Request for horizontal clearance waiver

The Washington State Department of Transportation (WSDOT) is currently preparing to reconstruct the SR-16 Nalley Valley Interchange over Sound Transit's tracks in Tacoma, Washington. The new SR-16 structure will cross over both the Sound Transit mainline (formerly the BNSF Lakeview Subdivision) and two adjacent spur tracks in the vicinity of railroad milepost 3.35. Design of this structure includes a bridge column that will be located immediately south of the spur tracks (highlighted in orange on Exhibit A, attached).

EXHIBIT B

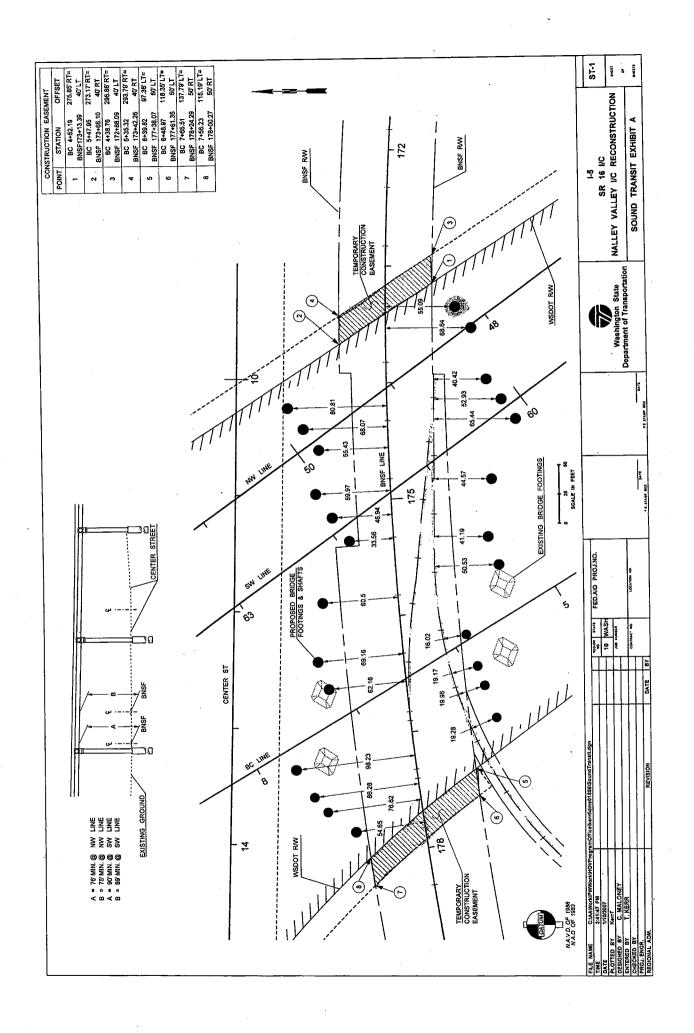
The permanent horizontal clearance between the face of the column and the track centerline is 8.7 feet, thereby complying with the clearance requirements of WAC 480-60-050. The column, however, will be constructed using formwork that will extend closer towards the tracks than allowed under the rule. WSDOT has consulted with both Sound Transit and Tacoma Rail regarding this matter, and was advised that a close clearance will be acceptable, provided that no portion of the temporary structure is placed closer than 4 feet from the outside top of rail (see Exhibit B, Sound Transit and Tacoma Rail correspondence). WSDOT subsequently revised the plan so that the distance between the edge of formwork and track centerline is 6.7 feet. This distance meets the condition required by the railroads for their concurrence with this request.

RAILROAD CONSTRUCTION CLEARANCE SPUR LINE

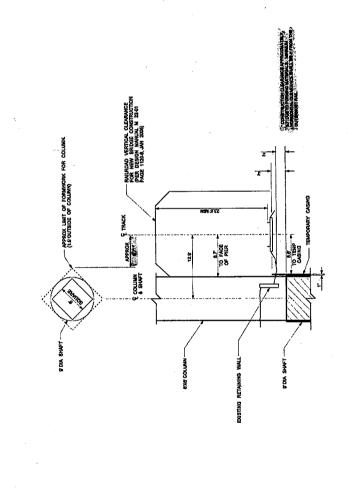
Tacoma Rail requires that the column and shaft forms are no closer than 4' from the field side of the nearest

Standard Gauge between the rails is 4' $8 \frac{1}{2}$ " and the ball of the rail is approximately 3". According to your plan the forms are approximately 3' 10" from the nearest rail.

Sound Transit has no issue with the clearance as depicted in the exhibit. I would ask that Kyle (or whomever he designates) confirm there is no issue with deliveries to potential TR customers with this clearance.

Thanks for your review. The project office has determined that complying with your restriction can be achieved by trimming or otherwise adjusting the corner of the forms. I will proceed to petition WUTC for this waiver under the condition that you stated.
